PCI-SIG ENGINEERING CHANGE NOTICE

TITLE:	TLP Processing Hints
DATE:	September 11, 2008
AFFECTED DOCUMENT:	PCI Express Base Specification version 2.0, Atomic Operations ECN
SPONSOR:	IBM, Intel Corporation, AMD, HP

Figure 7-xx-1: TPH Extended Capability Structure

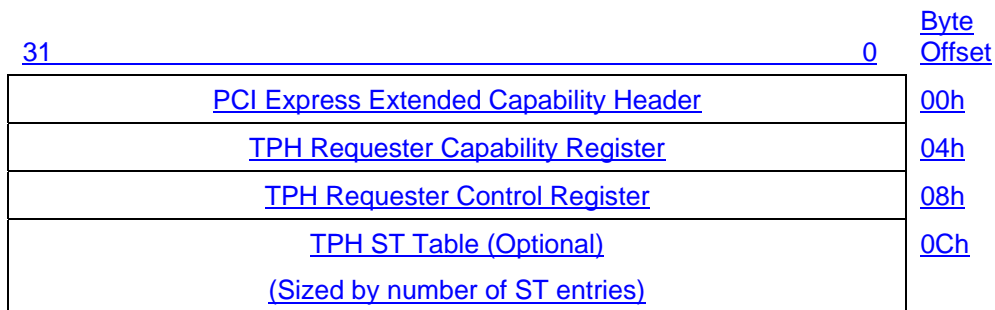
The TPH Requester Capability structure is required for all Functions that are capable of generating Request TLPs with TPH. For a multi-Function device, this capability must be present in each Function that is capable of generating Requests with TPH.

Figure 7-xx-3: TPH Requester Capability Register

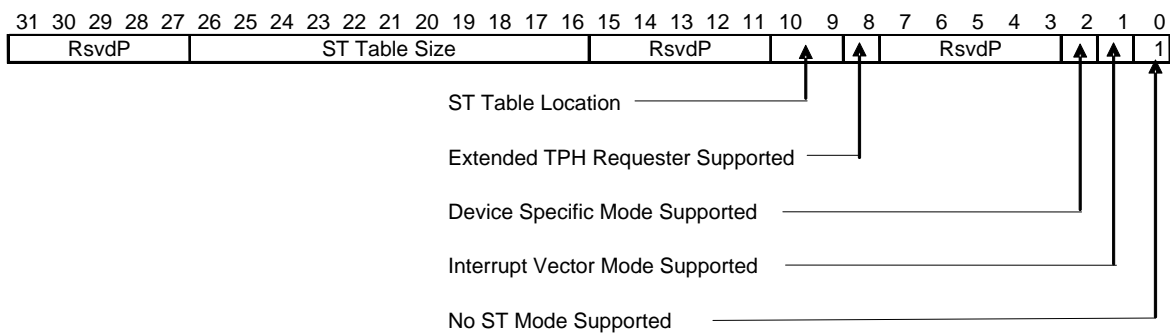
<u>Bit Location</u>	<u>Register Description</u>	<u>Attributes</u>
<u>0</u>	<p><u>No ST Mode Supported</u> – If set indicates that the Function supports the No ST Mode of operation.</p> <p>This mode is required to be supported by all Functions that implement this Capability structure. This field must have a value of 1b.</p>	<u>RO</u>
<u>1</u>	<p><u>Interrupt Vector Mode Supported</u> – If set indicates that the Function supports the Interrupt Vector Mode of operation.</p>	<u>RO</u>
<u>2</u>	<p><u>Device Specific Mode Supported</u> – If set indicates that the Function supports the Device Specific Mode of operation.</p>	<u>RO</u>
<u>8</u>	<p><u>Extended TPH Requester Supported</u> – If Set indicates that the Function is capable of generating Requests with a TPH TLP Prefix.</p> <p>See section 2.2.x.1 for additional details.</p>	<u>RO</u>
<u>10:9</u>	<p><u>ST Table Location</u> – Value indicates if and where the ST Table is located.</p> <p>Defined Encodings are:</p> <p>00 – ST Table is not present.</p> <p>01 – ST Table is located in the TPH Requester Capability structure.</p> <p>10 – ST Table is located in the MSI-X Table structure.</p> <p>11 – Reserved</p> <p>A Function that only supports the No ST Mode of operation must have a value of 00b in this field.</p>	<u>RO</u>

<u>26:16</u>	<p><u>ST Table Size</u> – Software reads this field to determine the ST Table Size N, which is encoded as N-1. For example, a returned value of “0000000011” indicates a table size of 4.</p> <p>There is an upper limit of 64 entries when the ST Table is located in the TPH Requester Capability structure.</p> <p>There is an upper limit of 2K entries when the ST Table is located in the MSI-X Table.</p> <p>This field is only applicable for Functions that implement an ST Table as indicated by the ST Table Location field. Otherwise, the value in this field is undefined.</p>	<u>RO</u>

Figure 7-xx-5: TPH ST Table

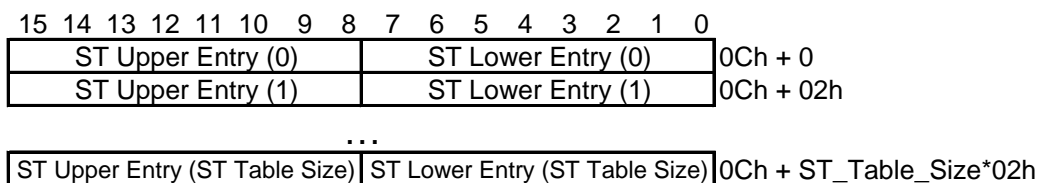
The ST Table must be implemented in the TPH Requester Capability Structure if the value of the ST Table Location field is 01b. For all other values, the ST Entry Registers must not be

implemented. The number of ST Entry Registers implemented must be equal to the number of ST entries supported by the Function, which is the value of the ST Table Size field plus one.
